Wisconsin Department of Transportation

NOTICE TO ALL CONTRACTORS:

Proposal #03: 5163-07-72, WISC 2025569
Genoa – La Crosse
Lacrosse Co Line to Sunnyside Dr
STH 35
La Crosse/Vernon County

This is Addendum No. 01, which provides for the following:

**42-INCH SINGLE SLOPED FACE
PARAPET TO 42-INCH SINGLE SLOPE
CONCRETE BARRIER TRANSITION**

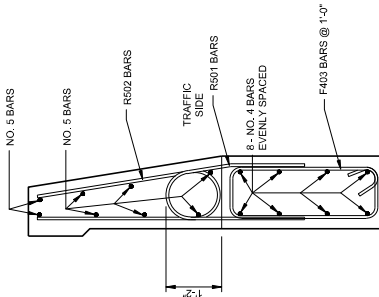
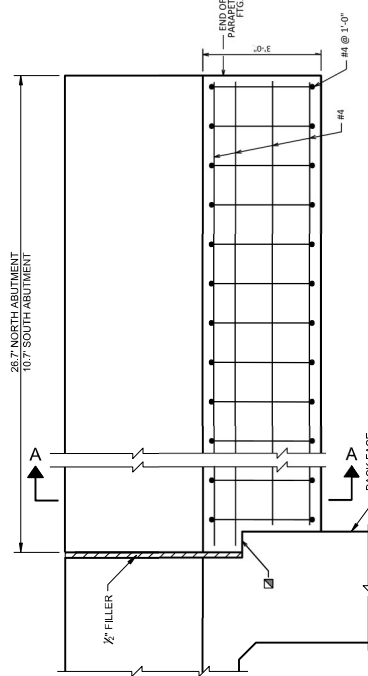
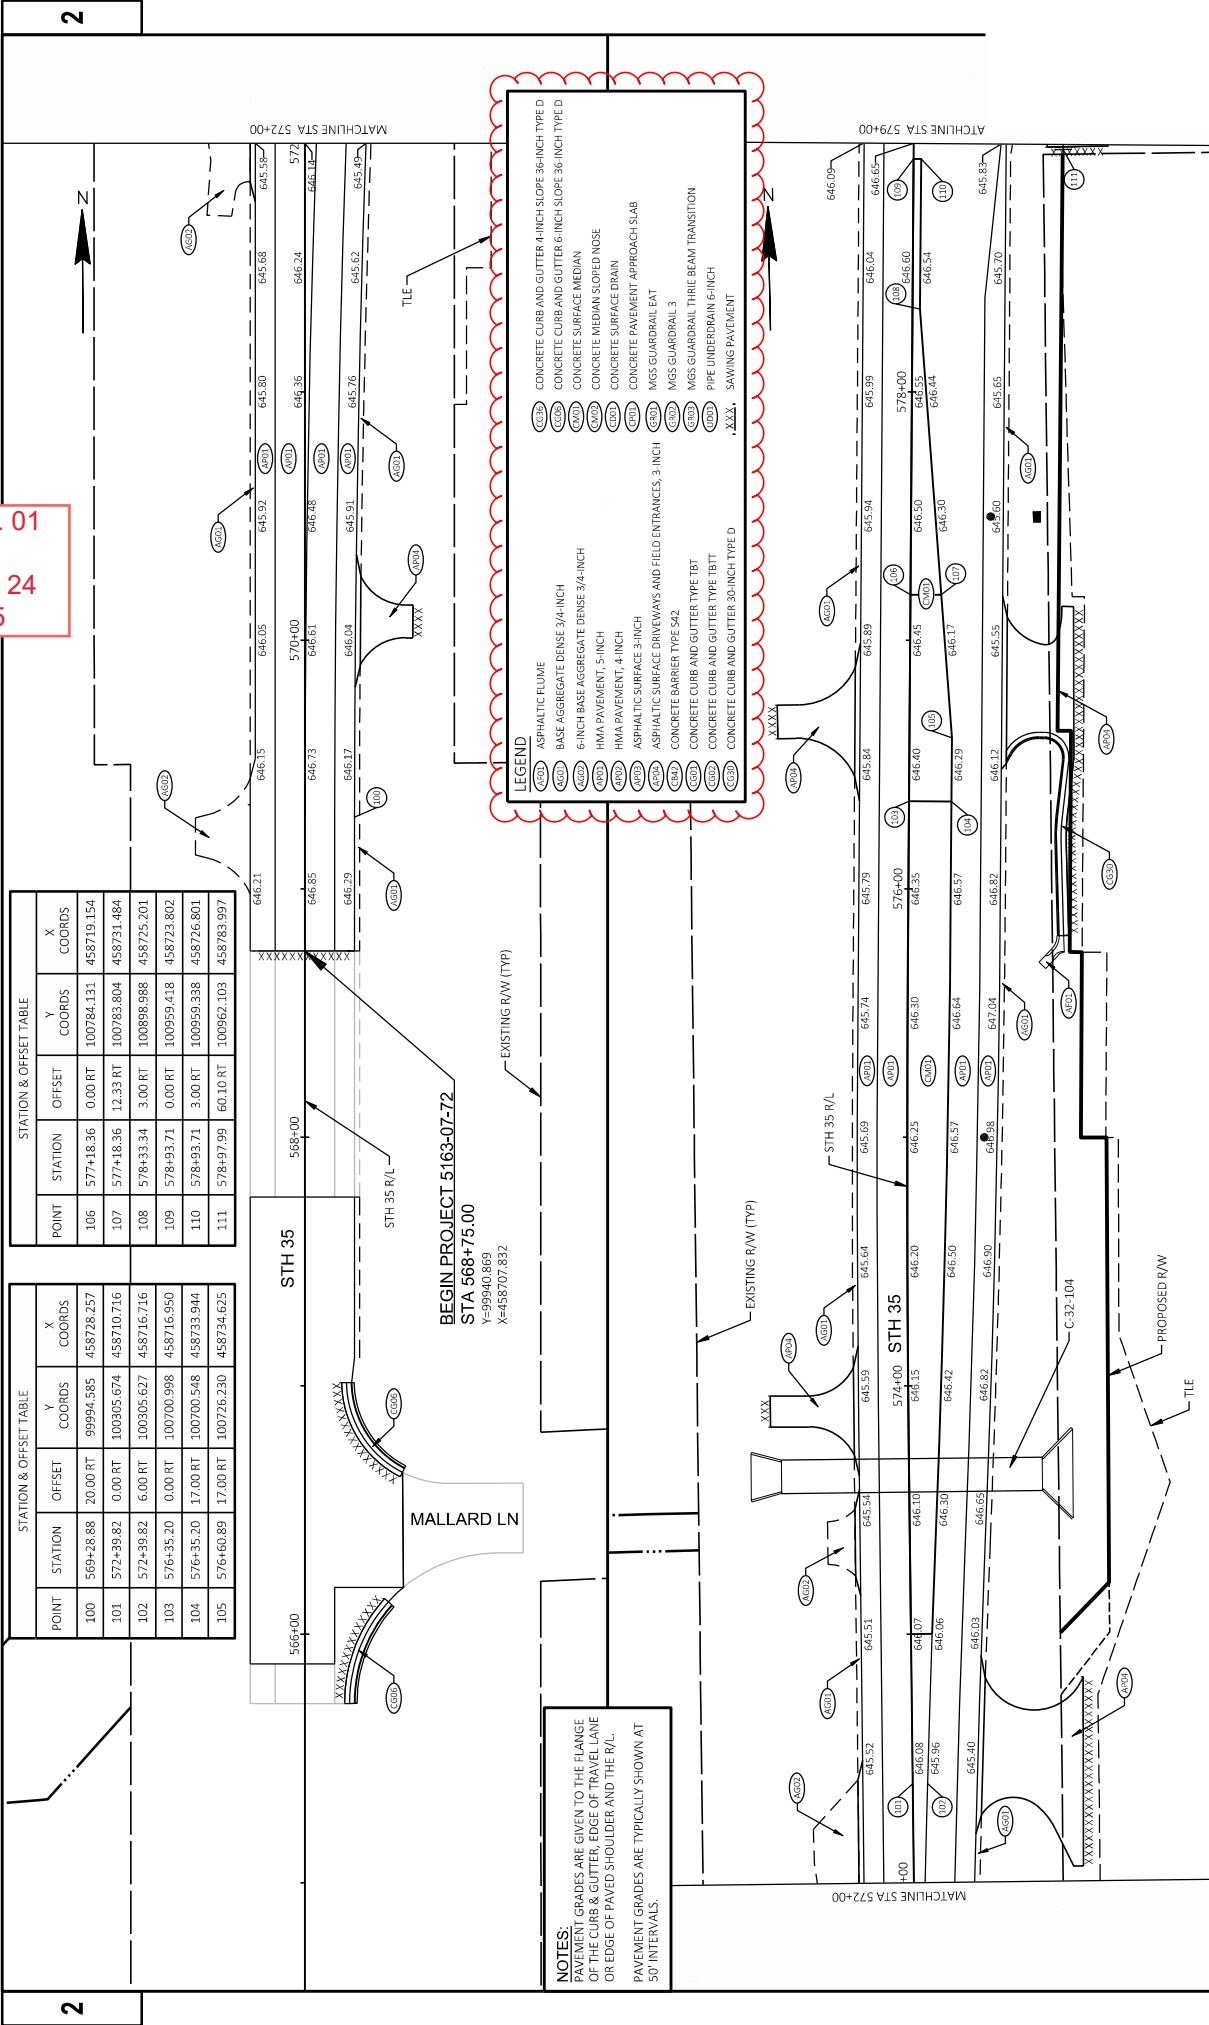
Revised Plan Sheets	
Plan Sheet	Plan Sheet Title (brief description of changes to sheet)
21	Construction Details (Updated the concrete barrier transition detail).
22	Construction Details (Updated the concrete barrier transition detail).
24-25, 27, 29-32	Plan Details (Updated the legend to show the removal of the Concrete Pavement 12-Inch bid item)
28	Plan Details (Updated the legend to show the removal of the Concrete Pavement 12-Inch bid item and change CP02 to the bid item label CP01 Concrete Pavement Approach Slab.)
139	Miscellaneous Quantities (Updated the 415-bridge approaches table to match plan detail updates. This includes removing the Concrete Pavement 12-Inch bid item and updating the Concrete Pavement Approach Slab bid item).
143	Miscellaneous Quantities (Updated the culvert pipe thickness).
149	Miscellaneous Quantities (Updated quantities for Driveway Assistance Device to match plan sheet).

STEEL TROWEL HORIZONTAL SURFACE OF PAVING NOTCH.
PLACE MULTIPLE LAYERS OF POLYETHYLENE SHEETS
BETWEEN PARAPET FOOTING AND HORIZONTAL SURFACE
OF PAVING NOTCH. TOTAL THICKNESS OF SHEETS SHALL
BE AT LEAST 6.05".
